APPENDIX C

QC and QA Construction Approval Forms and Site Correspondence

BAY-GOOSE DIKE CONSTRUCTION CHECKLIST - FOUNDATION PREPARATION and EXCAVATION

APPROVAL PACKAGE 31+805 to 31+820m

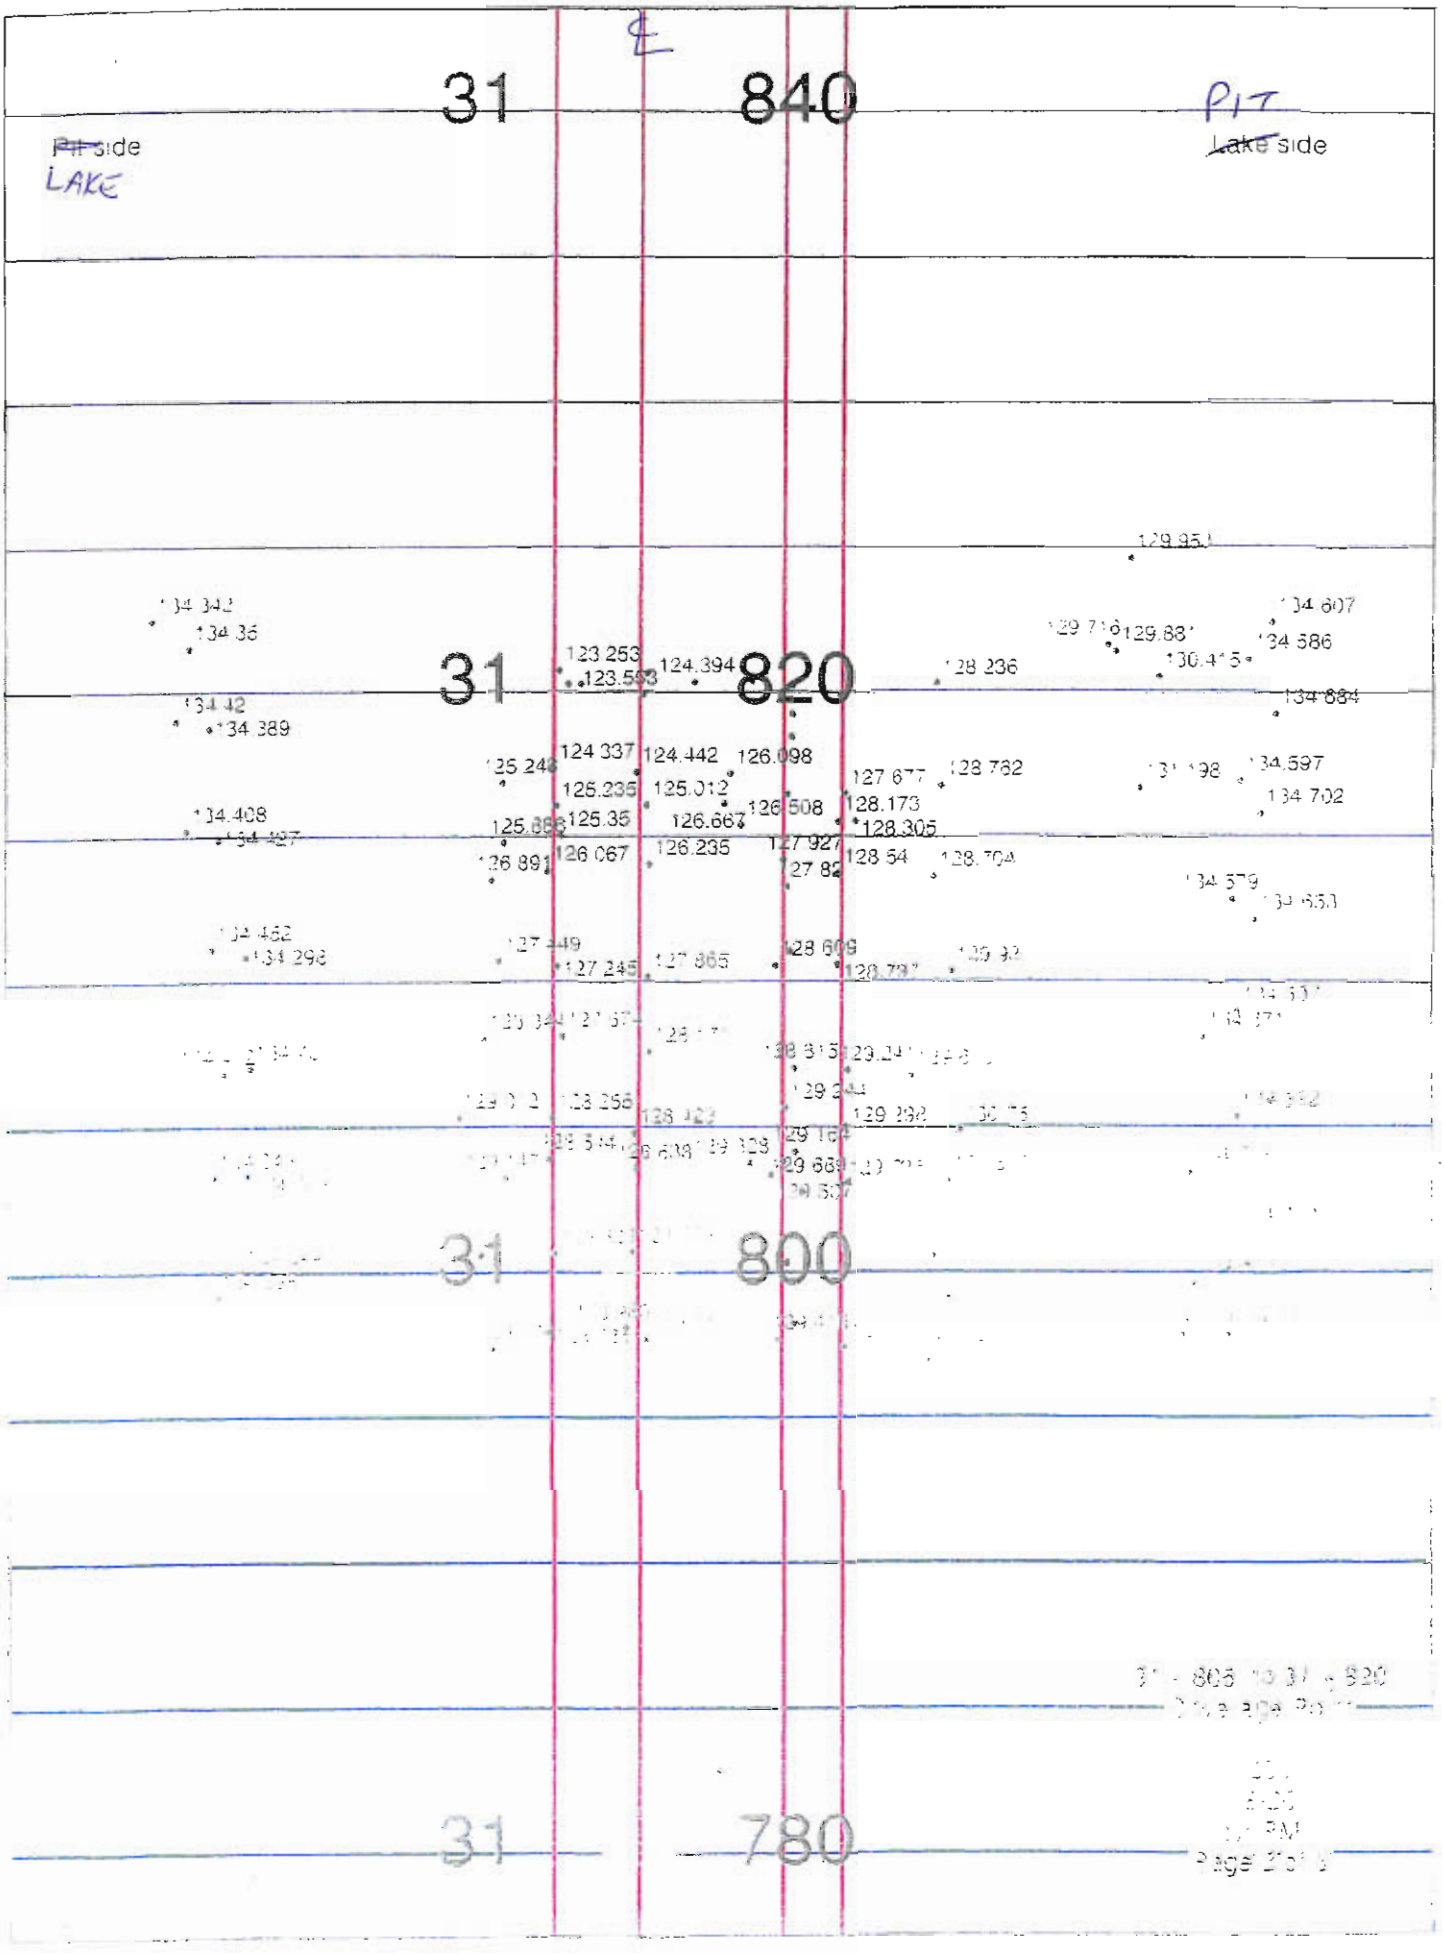
- AFTER RECEIVING ORIGINAL FOUNDATION APPROVAL PACKAGE I REQUESTED ADDITIONAL SURVEY (MANUAL SOUNDINGS) BETWEEN ℄ + 5m DOWNSTREAM
- ADDITIONAL POINTS WERE TAKEN, BUT ALONG 5m ALIGNMENT FROM ℄ ON DOWNSTREAM (D/S) SIDE. THIS IS NOT WHAT WAS REQUESTED
- RECEIVED NEXT PACKAGE @ ~8:30 PM.
- REVIEWED FIELD INSPECTOR NOTES (AGAIN)
- REQUESTED ADDITIONAL POINTS ALONG 31+820m WHICH WERE PROVIDED.
- 31+815 INDICATES SHARP CHANGE IN BEDROCK PROFILE TO PIT SIDE IMMEDIATELY ADJACENT TO ℄
- TARMAC UNABLE TO REACH THIS DEPTH TO CARRY OUT CHIPPING.
- TO FACILITATE WORK CHANGED ℄ ALIGNMENT BY 0.5m U/S. CONTACT WITH GASTON BLANCHETTE WAS ATEMPED PRIOR TO CHANGE.
- TO BLEND CHANGE OF ℄ START CHANGE @ 31+812m
- WILL BLEND BACK TO ORIGINAL ALIGNMENT WHEN APPROPRIATE.
- BEDROCK WAS CLEANED PRIOR TO PUSH OF BACKFILL PUSH.

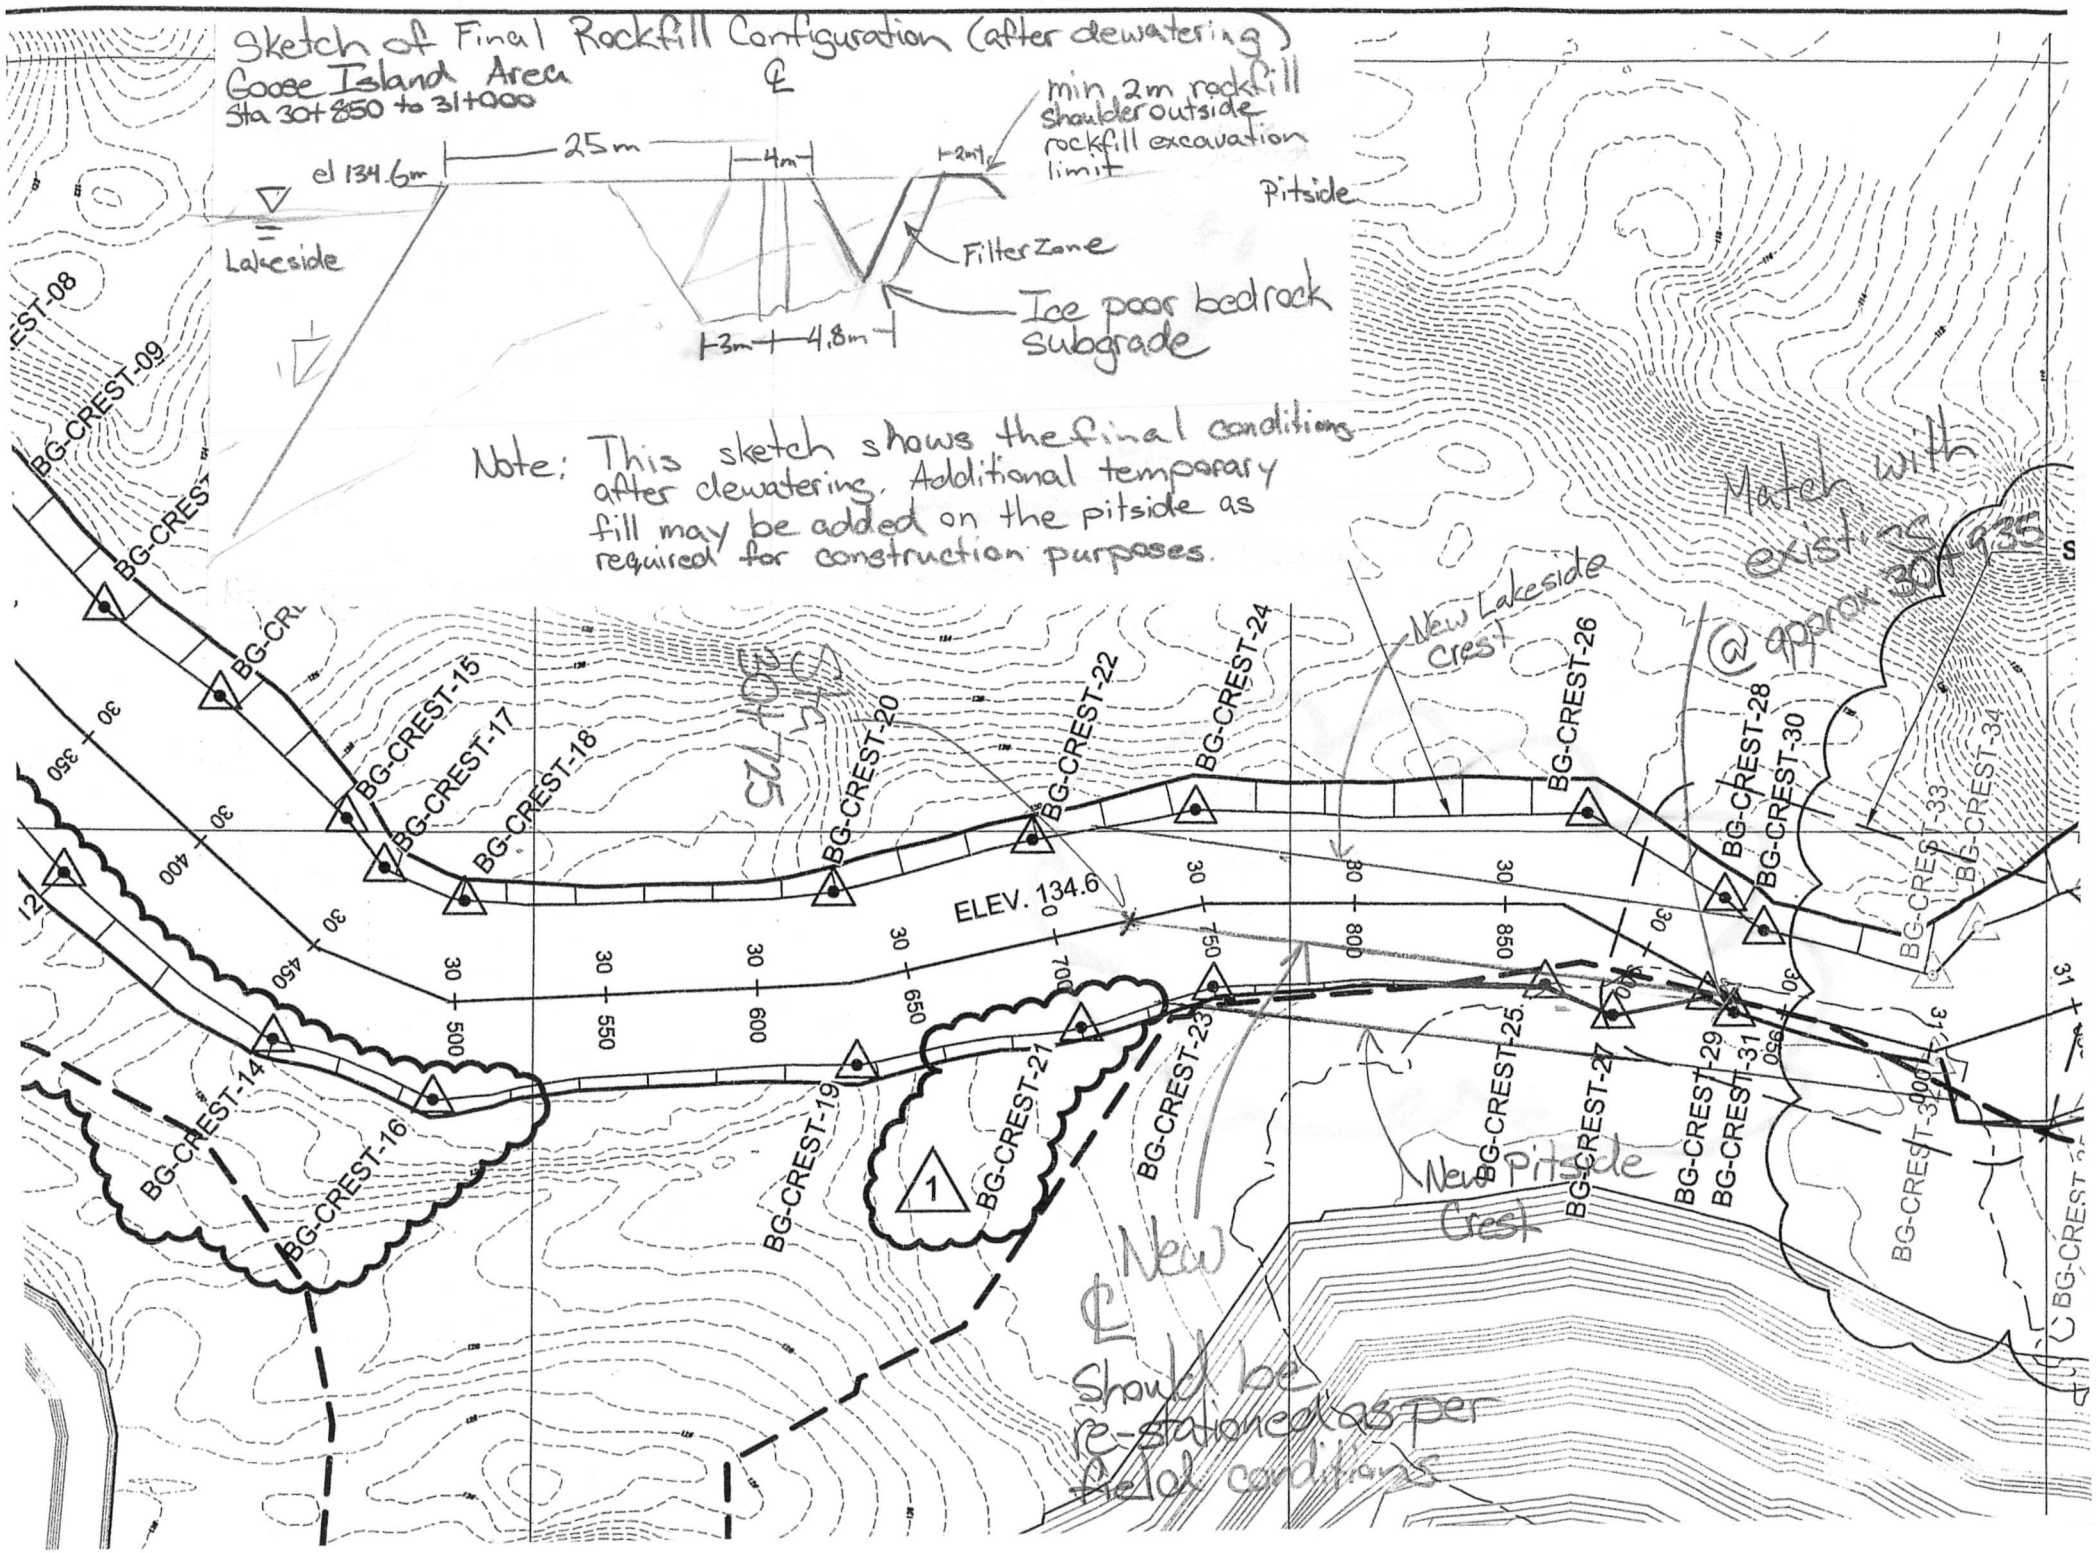
The alignment shown on Drawing 4200-03 Rev 0 will be changed such that a new centerline will be created from the existing centerline at station 30+725 in a straight line to point BG-CL-10 at approximately centerline station 30+935. The attached sketch shows the revised centerline in plan.

Please note that on Drawing 4200-04 Rev 1 rockfill crest control points BG-CREST-23 to 28 will be invalidated by this re-alignment. New points can be field fit by following the minimum width requirements on Drawing 4200-06 Rev 1.

As noted on the sketch, it shows only the final configuration after dewatering. Any additional, temporary fill on Goose Island to the west of the final plan area does not require stripping.
